Bunker Hill Redevelopment

Phase 1 - Buildings F & M

BCDC Meeting – April 6, 2021

ADDITIONAL TREES EVALUATED

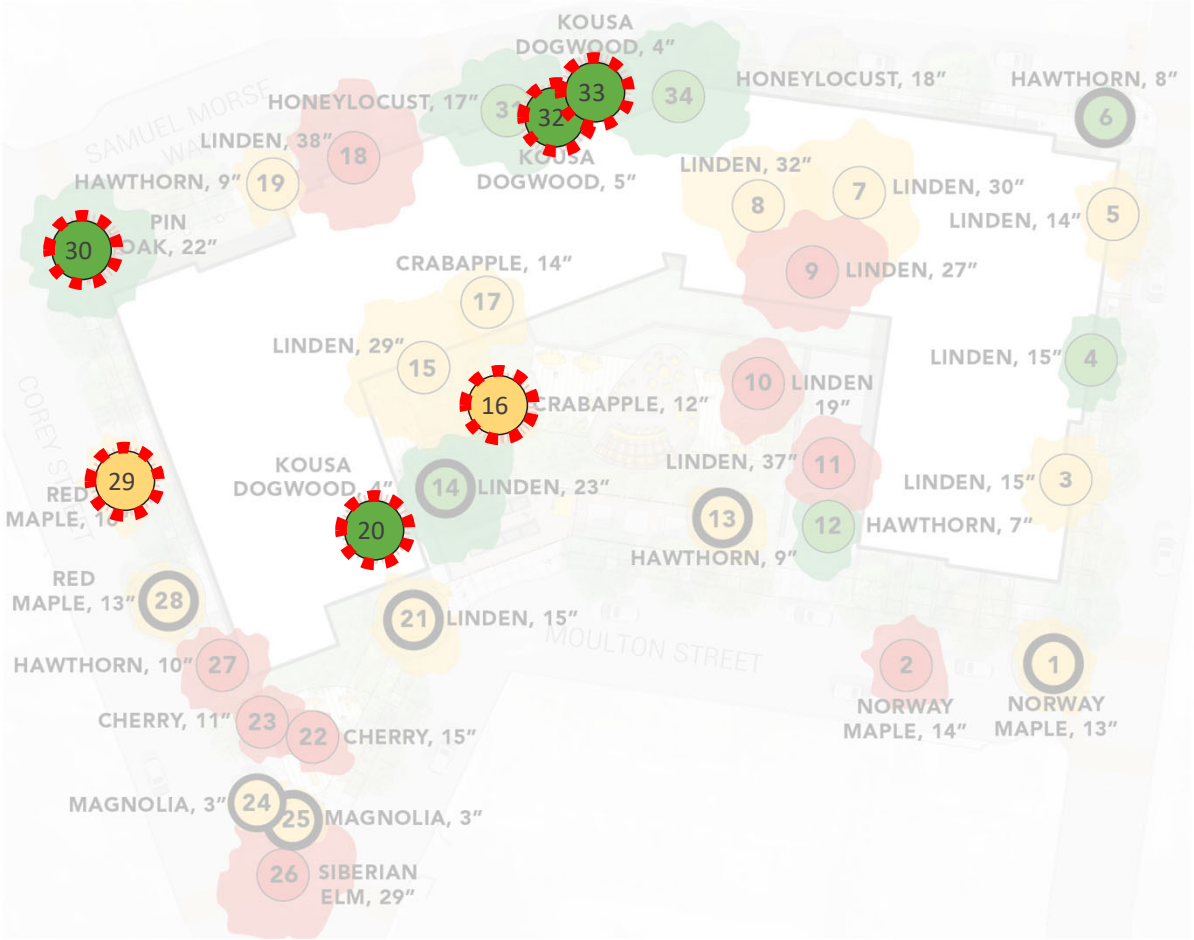
- transplant (3) Kousa Dogwoods – #20, 32, and 33
- adjust street parking to preserve 16" Red Maple (#29)

- 2" Crabapple (#16) – would not survive due to subsurface infrastructure and required grading considerations, even if courtyard adjusted
- 22" Pin Oak (#30) by adjusting streetscape. Pink Oak would not survive due to substantial root zone reduction.

ADDITIONAL TREES EVALUATED

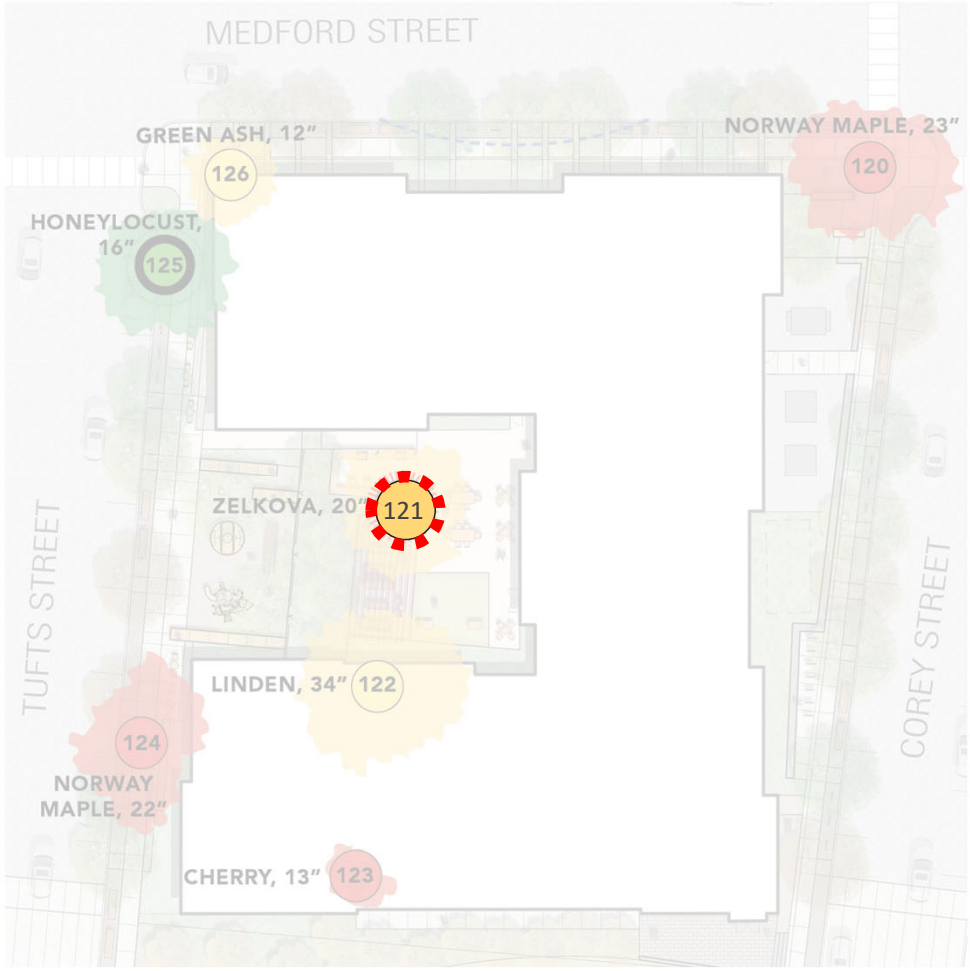
- Potential to adjust courtyard to preserve 20" Zelkova (#121). Preserving Zelkova would reduce the size of the amenity space by 30%
